Access Compliance Report Public Rights-of-Way (Curb Ramps)

Intersection ID: 24576 Main Street: HUNTSCROFT_LN Cross Street: REA_CROFT_DR Location: W

ADA ID: 3CEF73F94756 Ramp Type: BlendTrans2 Initial Pass/Fail: Fail Overall Compliance: No Severity Score: 8.75

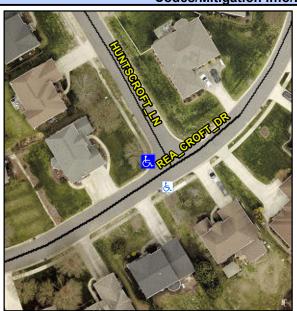
PROW/ADA:
Not Found, R304.5.1

REA CROFT DR None HUNTSCROFT LN StopSign Possible Solutions:

Remove & Replace Curb Ramp With
Two New Directional Ramps or
Equivalent.
